Melbourne Metro Rail Project EES Inquiry and Advisory Committee (IAC)

Statement of landscape and open space evidence

Stephen Schutt of Hansen Partnership Pty Ltd.

on behalf of the City of Stonnington

Figure 21: South Yarra Siding Reserve residential walking catchment - existing.

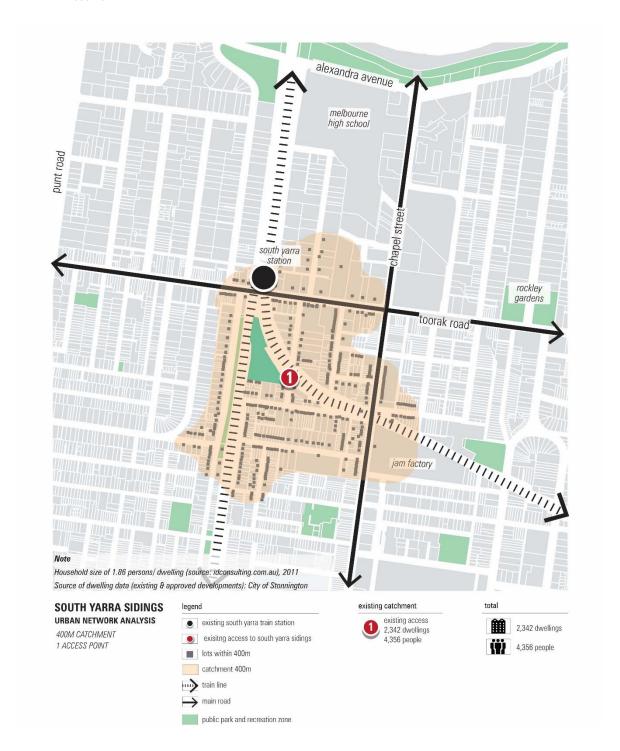
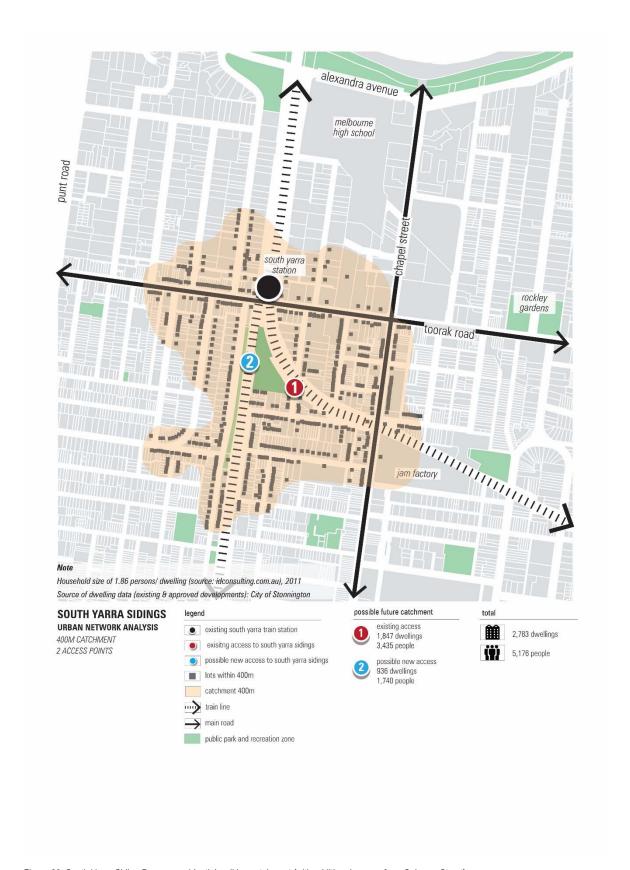
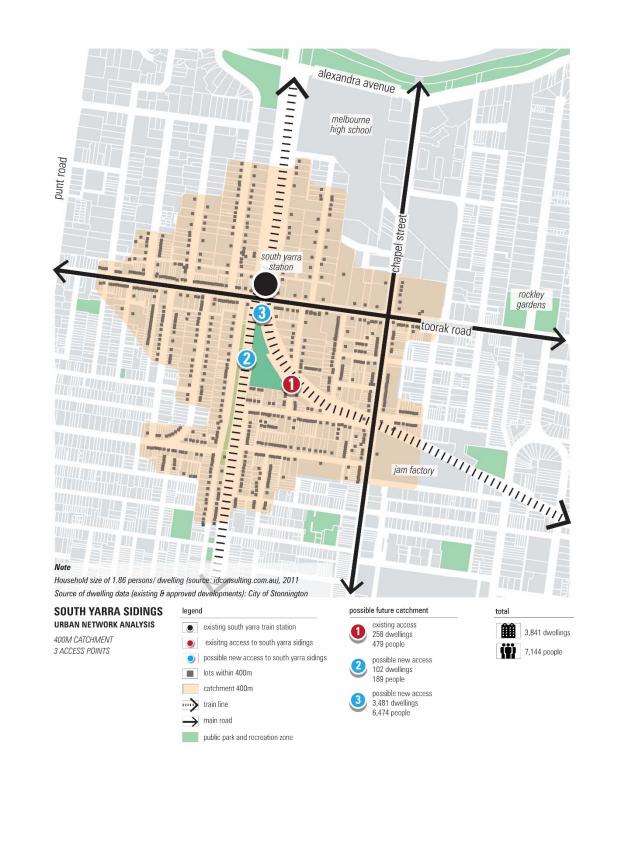
60. The following diagrams illustrate the benefits of providing additional points of access to South Yarra Siding Reserve.

61. In summary, the analysis undertaken using the UNA software has determined that the existing resident population who are able to access South Yarra Siding Reserve within a 400 metre walking distance is in the order of 4,356 people. The provision of a single additional point of access to the Reserve, providing a connection to Osborne Street over the Sandringham Railway Line, increases the resident population within a 400 metre walking distance of the Reserve to 5,176 people (an increase of approximately 20%). The provision of a further additional point of access to the Reserve, providing a connection to Toorak Road, further increases the resident population within a 400 metre walking distance of the reserve to 7,144 people (a further increase of 40%). Importantly, the analysis demonstrates that the majority of the resident population who would directly benefit from the provision of a connection between South Yarra Siding Reserve and Toorak Road reside within the Forrest Hill Precinct. As the population in this part of South Yarra continues to grow (as anticipated) then so too does the value (with respect to net community benefit) of a pedestrian connection to Toorak Road, as a means of providing the residents of the Forrest Hill Precinct (and others) with access to local public open space within a 400 metre walking distance.
